# TENNESSEE VALLEY AUTHORITY

July 20, 1983

Please refer to your letter to H. C. Parris dated April 26, 1983 concerning the Safety Evaluation Report (SER) for Environmental Qualification of Safety-Related Electrical Equipment at the Sequoyah Nuclear Plant (SQNP). Previous correspondence regarding this letter was submitted from L. M. Mills to you on May 12 and June 2, 1983.

Equipment Requiring Justification for Continued Operation

TER Item No. 137  
Figure 2

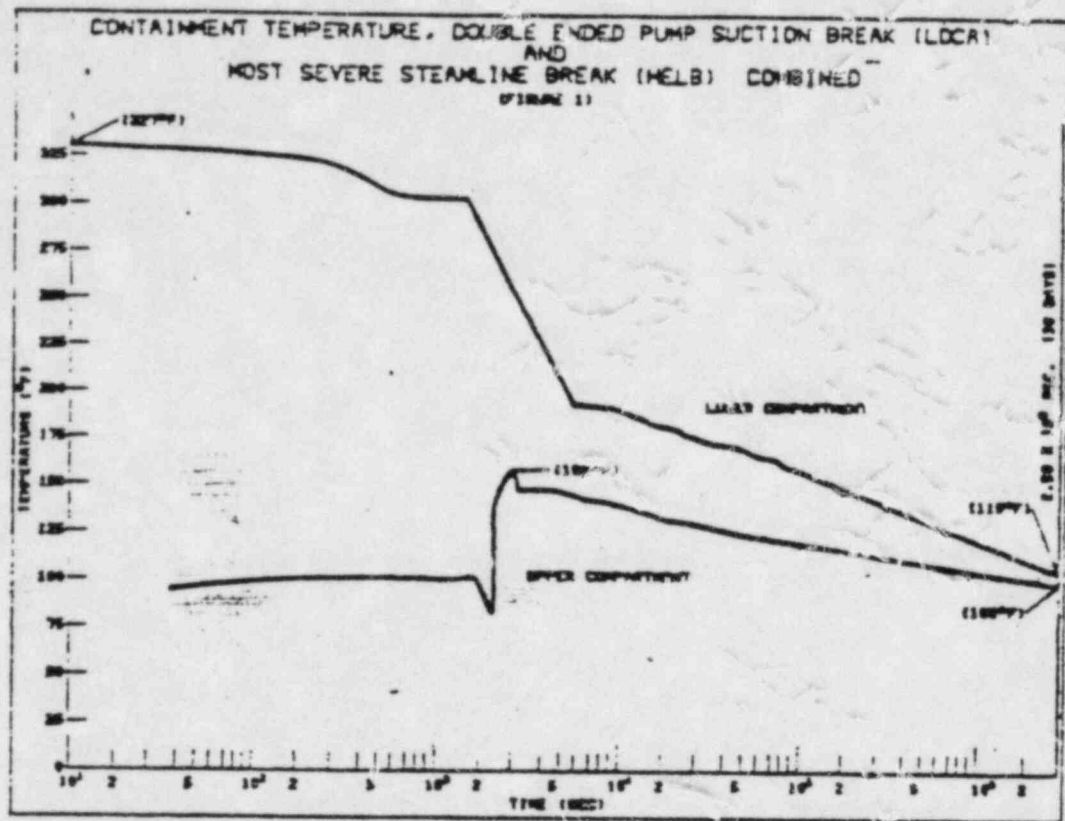
The manufacture's LOCA test profile (figure 1) more than satisfies the requirements of the actual MSLB/LOCA Profile (figure 2). In addition, the LOCA test extends out to 722 hours (30 days) at 200°F which is a more severe environment than denoted by the latter portions of the actual LOCA profile.

Based on Engineering judgment, the above information justifies qualification of limit switches for their accident and post-accident environment.

Figure 1. LOCA Simulation Test Profile

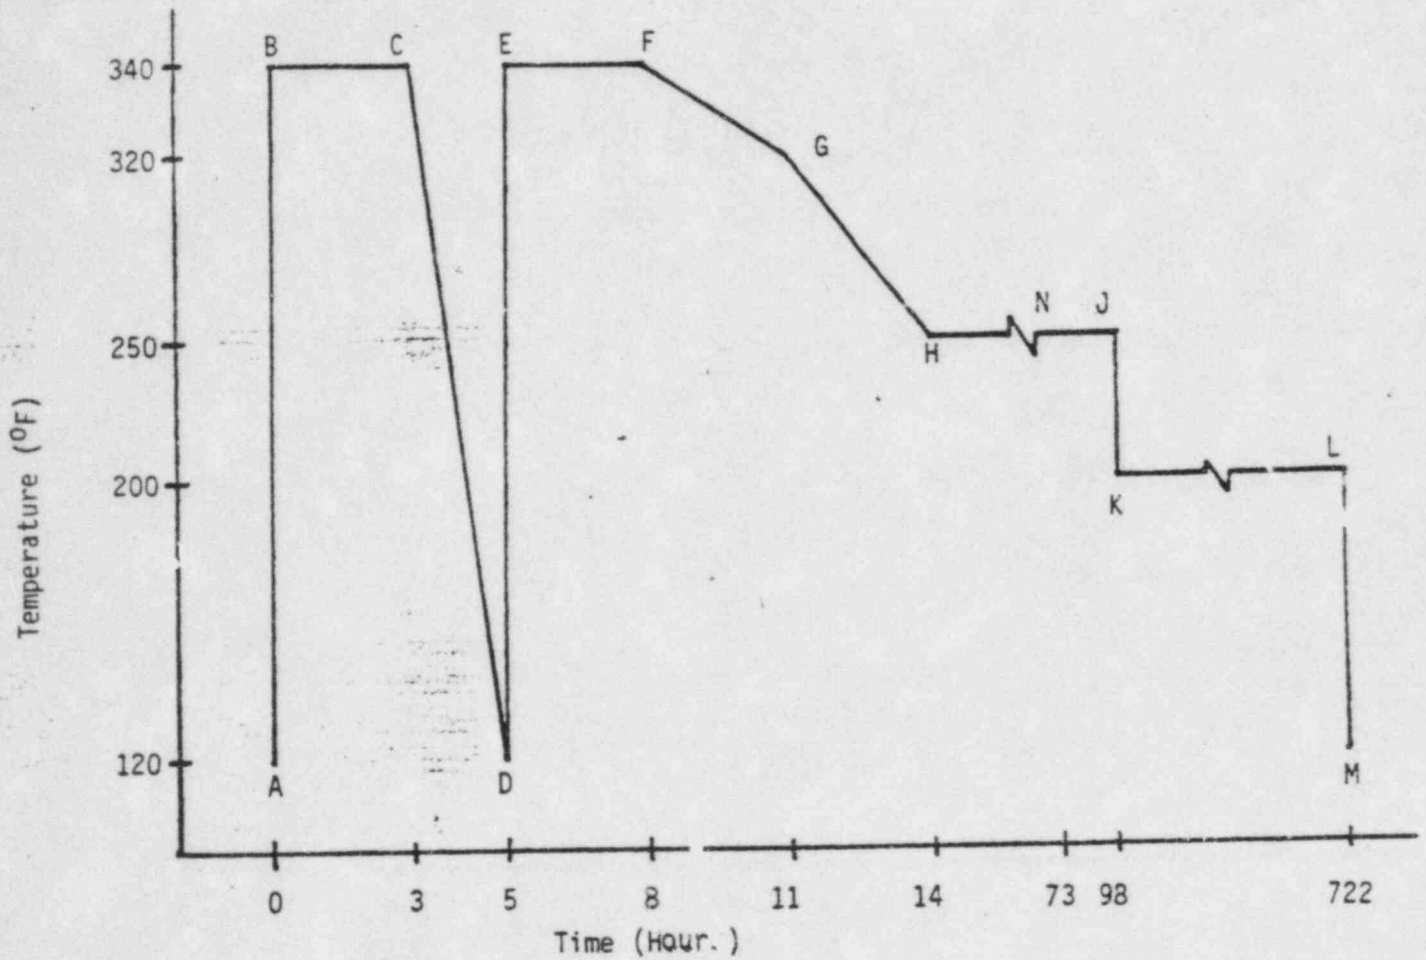
The manufacture's LOCA test profile (figure 1) more than satisfies the requirements of the actual MSLB/LOCA Profile (figure 2). In addition, the LOCA test extends out to 722 hours (30 days) at 200°F which is a more severe environment than denoted by the latter portions of the actual LOCA profile.

Based on Engineering judgment, the above information justifies qualification of limit switches for their accident and post-accident environment.
